**ANN ARBOR HISTORIC DISTRICT COMMISSION****Staff Report****ADDRESS:** 1017 W Liberty Street, Application Number HDC22-1144**DISTRICT:** Old West Side Historic District**REPORT DATE:** August 11, 2022**REPORT PREPARED BY:** Jill Thacher, Historic Preservation Coordinator**REVIEW COMMITTEE DATE:** August 8, 2022

**APPLICATION:** The applicant seeks HDC approval to pave a strip between the house and driveway and replace a wood overhead garage door with a steel overhead door.

1017 W. LIBERTY ST

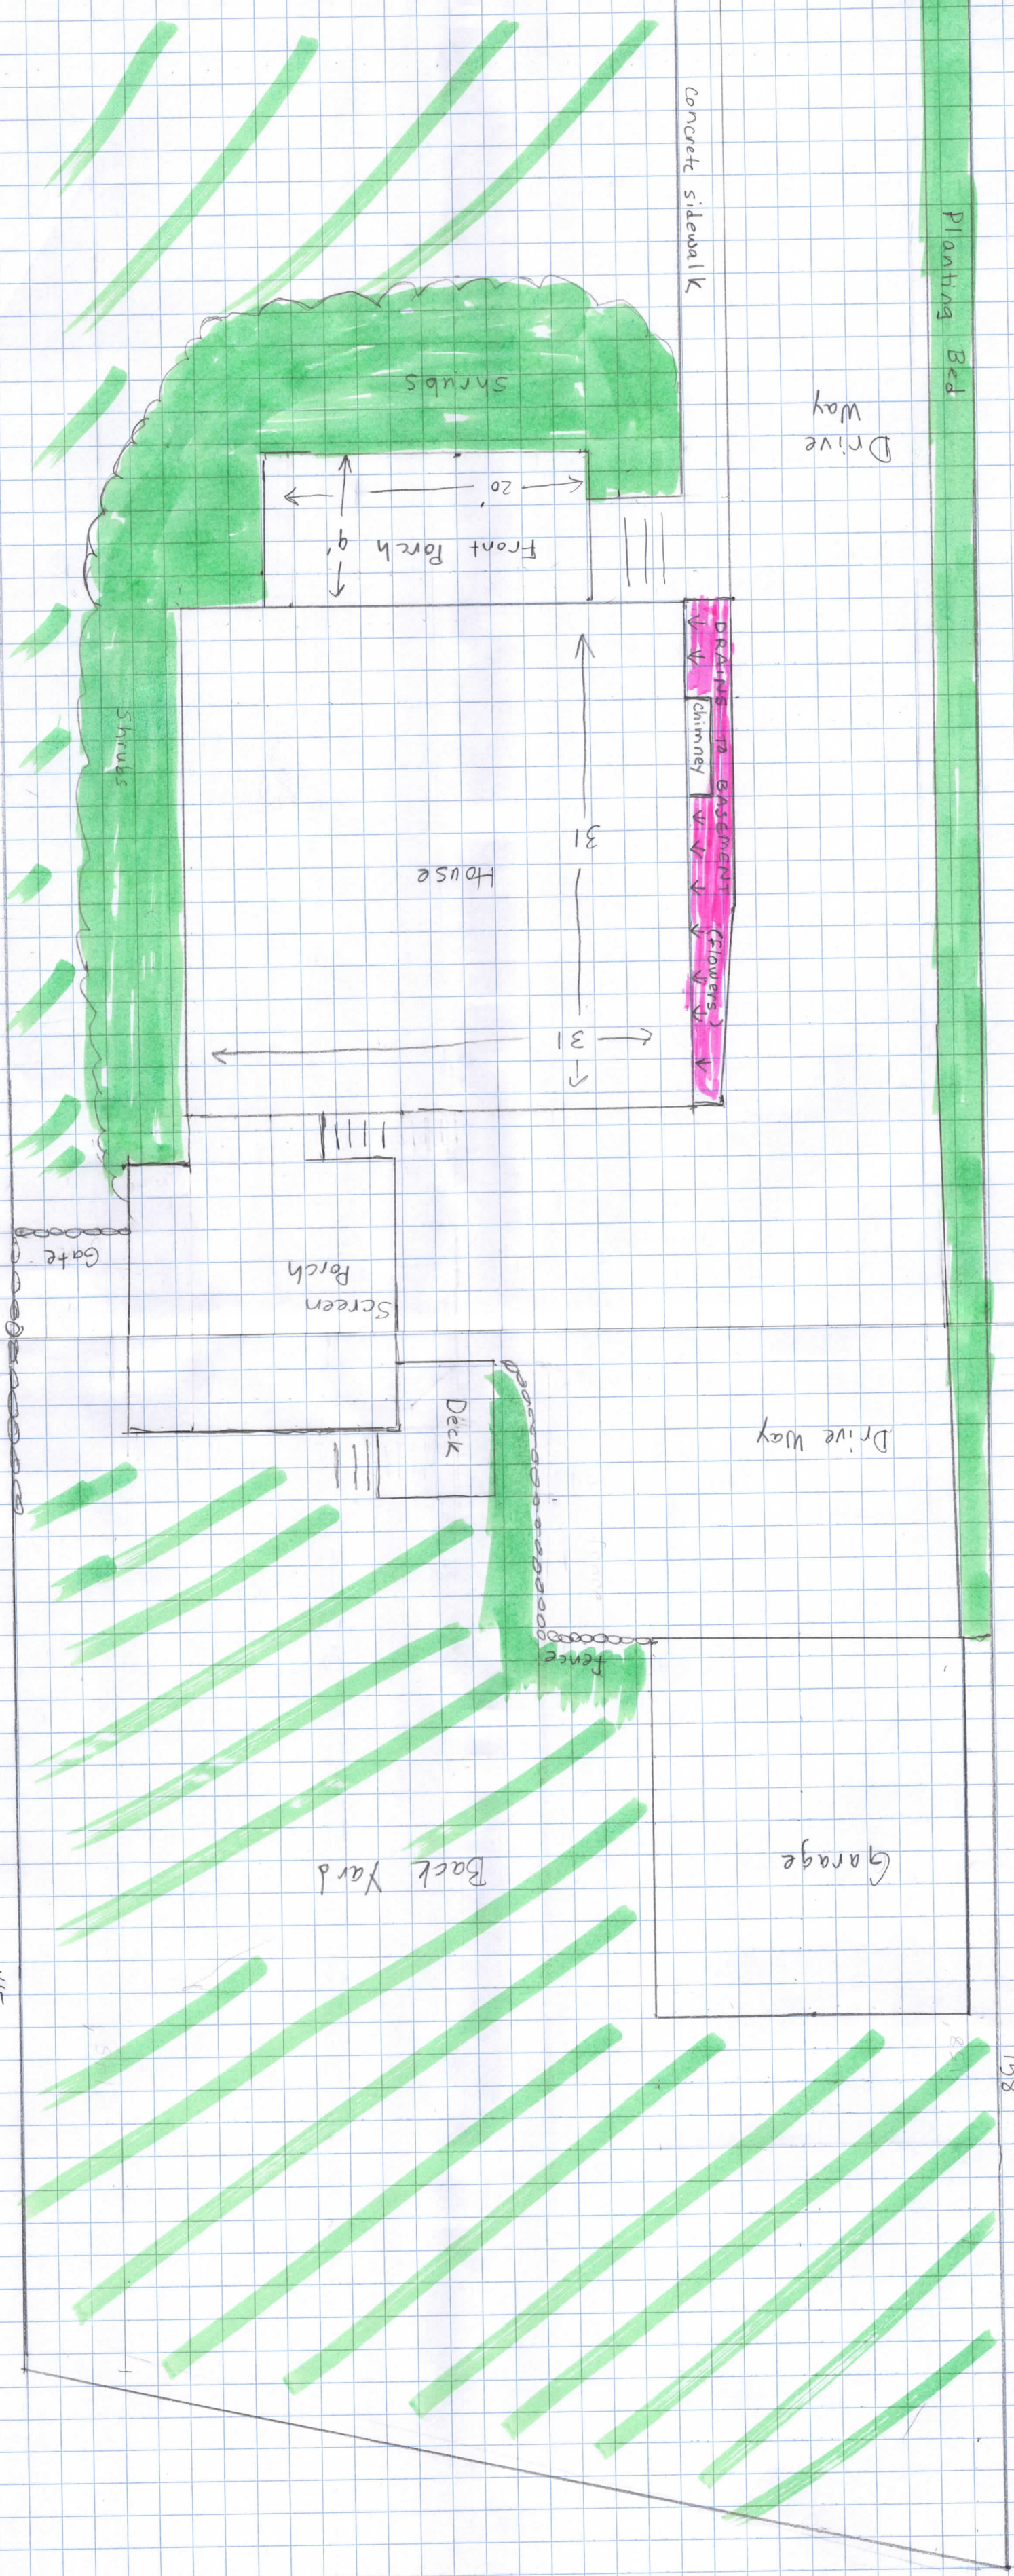
1. *Paving*. In the application is an excellent summary of the proposed work and why it is necessary. In a nutshell: water infiltration is causing cracking, bowing, and settling in the basement walls, and it is necessary to divert water away from the foundation on the east side of the house to avoid further degradation. Concrete paving is proposed between the east elevation of the house and the concrete driveway. The first floor of the house is brick that extends all the way to the ground. The basement walls are poured concrete.

2. The proposed work appears to have been thoroughly researched by the homeowner. Despite the *Ann Arbor Design Guidelines for Historic Districts* stating that it is appropriate to maintain the green space between the house and driveway, paving the strip is a way to resolve a much more serious issue, and the work is reversible.

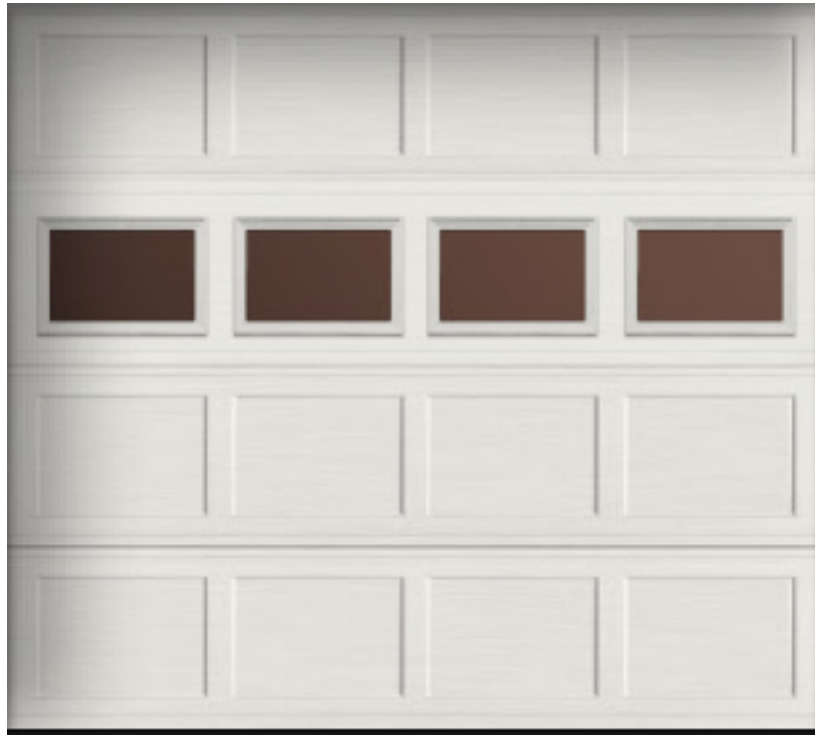
3. *Garage doors*. The garage is a contributing historic structure that is also in need of repairs, which are documented in the application. The current roll-up/overhead doors are wood. The bottom panels are rotted, cables are loose and seals are poor. Replacing just the lowest panel row is not an option, per the application.

4. Material changes must be reviewed by the HDC, not staff. The age of the wood overhead doors is unknown, but the garage is from the period of significance. It is likely that the garage was built at the same time as the house. Whether it originally had double-leaf doors or overhead doors is unknown. Staff generally supports this request for steel overhead doors that are similar in style and appearance to the wood ones, but looks forward to feedback from the Commission on this issue.
